Submission on Rotokauri Strategic Infrastructure Designation Notice of Requirement, Hamilton City Council

Rotokauri Development Limited ('RDL') welcomes the opportunity to provide feedback on the Rotokauri Strategic Infrastructure Designation Notice of Requirement ('NOR') as prepared by Hamilton City Council ('Council').

A NOR has been lodged by HCC to designate land for the construction and operation of a minor arterial transport corridor to provide key future transport connections to enable the urban development of Rotokauri, as guided by the Rotokauri Structure Plan.

Figure 6: Roading Drawings [Appendix B.2].

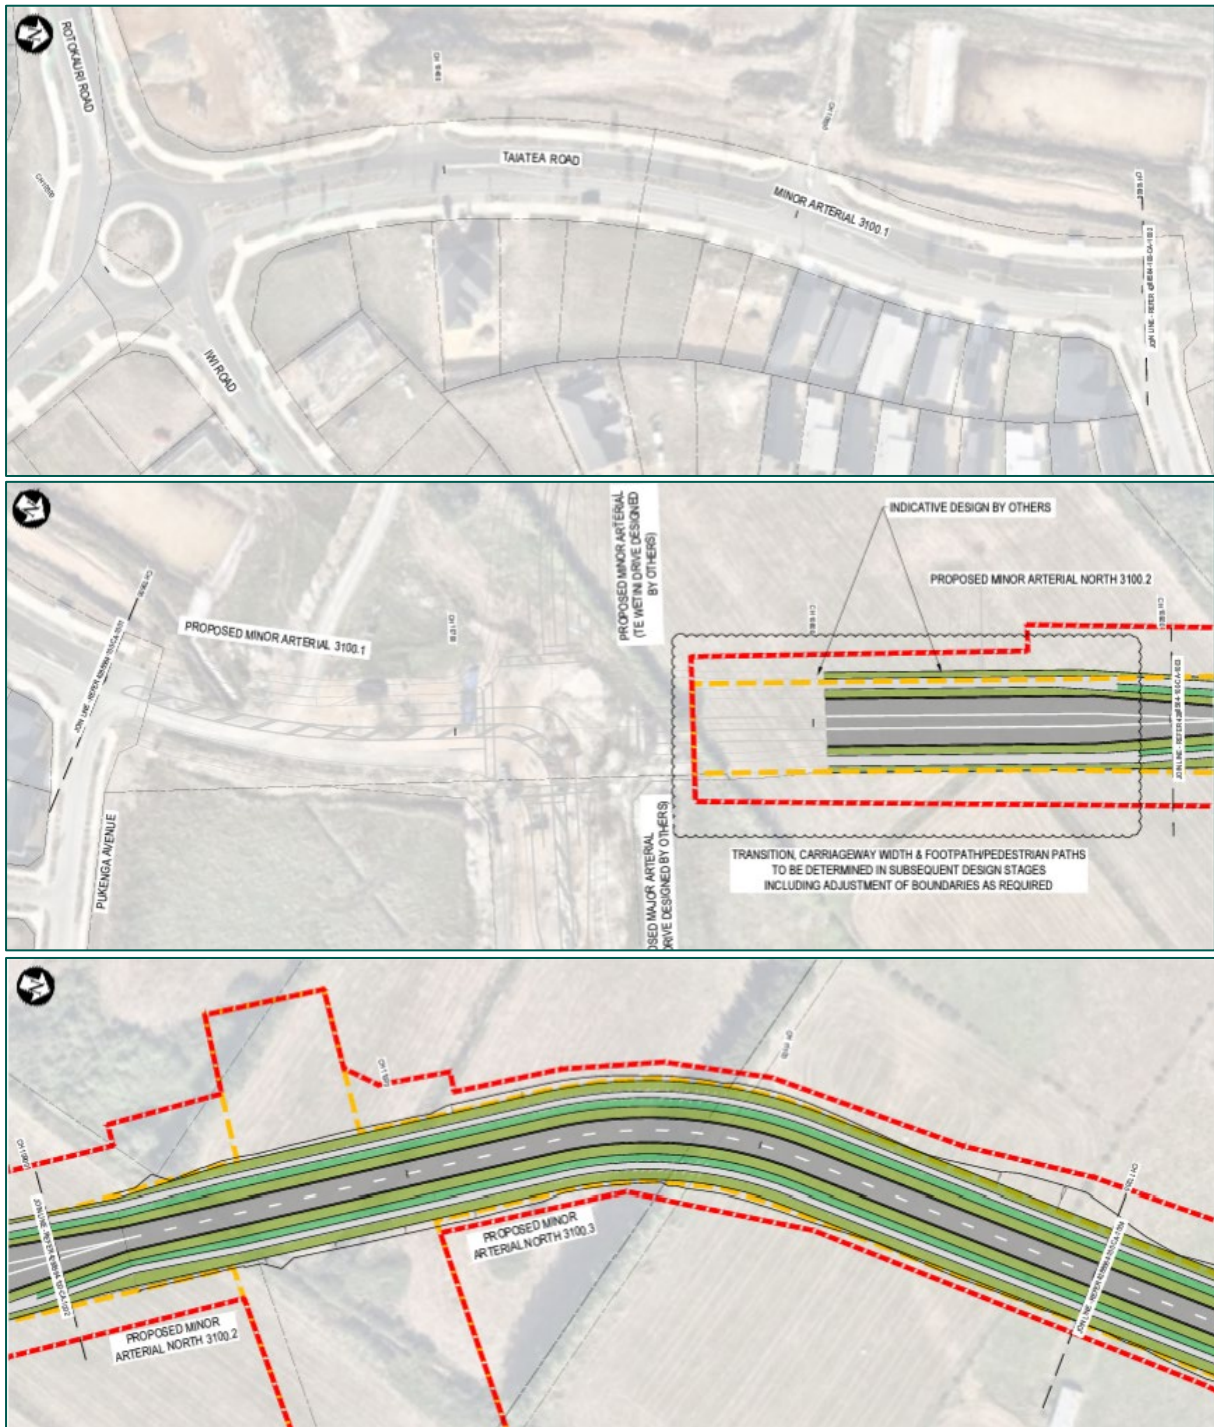
The Roding Drawings [Appendix B.2 in the NOR documentation] shows a low point in the transport corridor at approximately RL33.50 metres. This means low lying areas of the property will be below this level and will require filling to lift the connecting transport corridors to the Minor Arterial transport corridor and building platforms above the spill point.

Hence, it is critical that the vertical alignment of the Minor Arterial transport corridor carefully considers the secondary overland flow paths and the effect on upstream development land. The existing sag in the vertical alignment in the vicinity of Culvert 2 should be kept as low as possible to limit the required fill to lift the property above the low point.

RDL seeks circulation of the design pack to provide feedback and ensure efficiency and integration with their proposal for the property. Further, it is requested that the vertical alignment of the Minor Arterial transport corridor be designed to the lowest practicable level.

Figure 7: Stormwater Drawings [Appendix B.3].

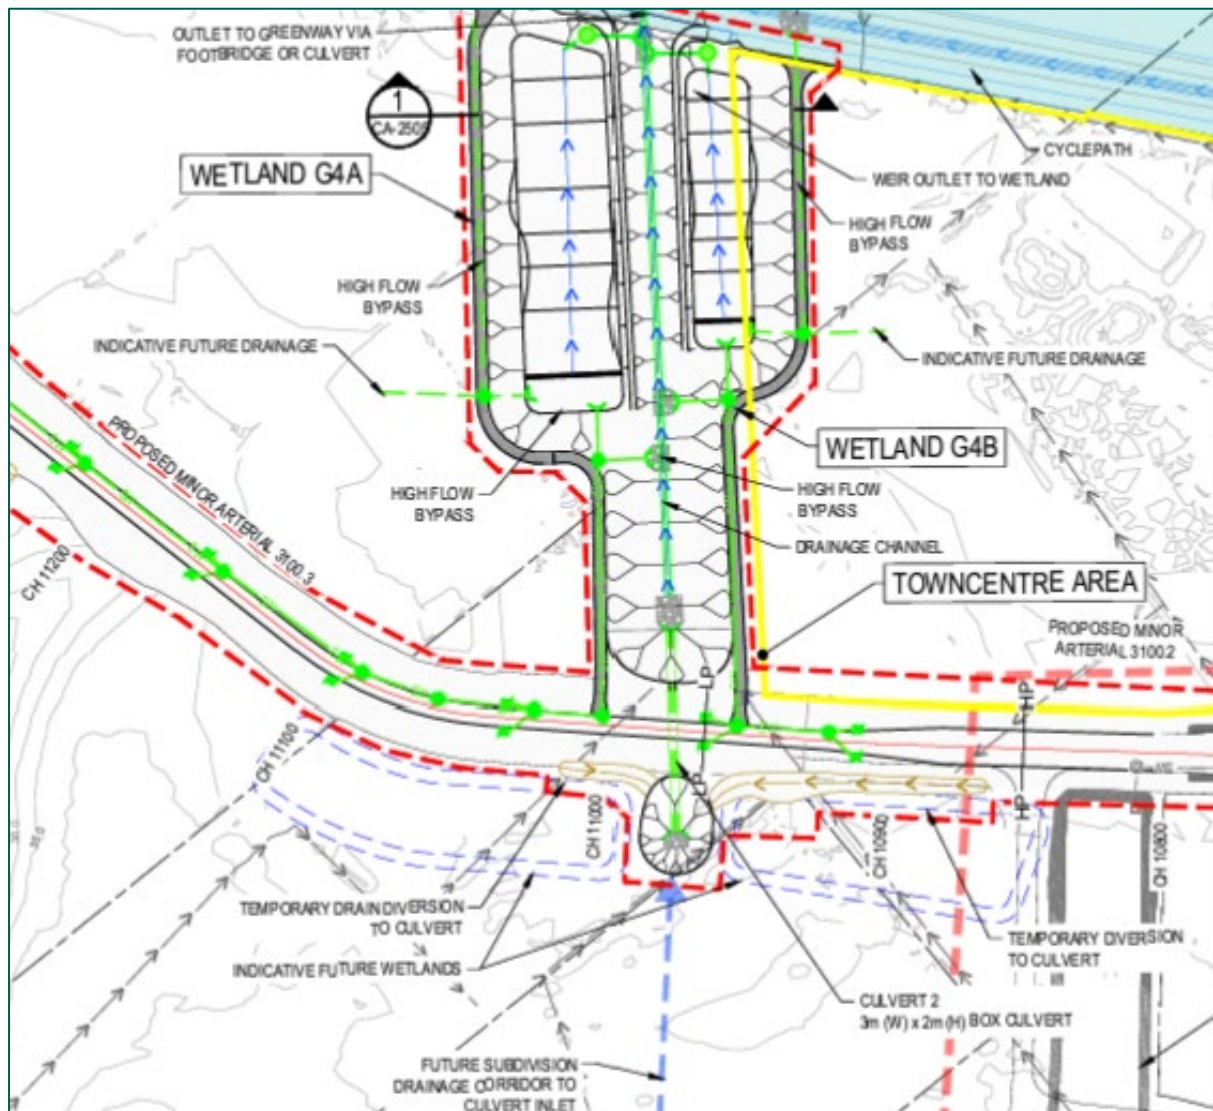
As shown in **Figure 7**, “indicative future wetlands” are shown on the property, which are not included within the designation footprint. Section 5.6 of the Design Report [Appendix D in the NOR documentation] states, *“Only wetlands that receive runoff from the proposed roads will be included within the proposed designation. This leaves several wetlands identified in the Greenway NoR and ICMP documents to be designed and developed in the future as part of adjacent subdivision developments. These other wetlands are indicatively shown on the drawings to show the wider stormwater management context.”*.

RDL seek flexibility in relation to the “indicative future wetlands” particularly their location, sizing and design. They straddle several property boundaries, which is unrealistic and undeliverable.

Initially, the relief sought is the removal of these “indicative future wetlands” from the NOR drawings.

Otherwise, RDL seek that all “indicative future wetlands” are labelled with the statement: “Any indicative future wetlands are an indicative option for providing stormwater storage outside of the constructed Greenway. Each land owner will determine, design and consent the actual design, location and size of any additional stormwater storage device related to their property.”
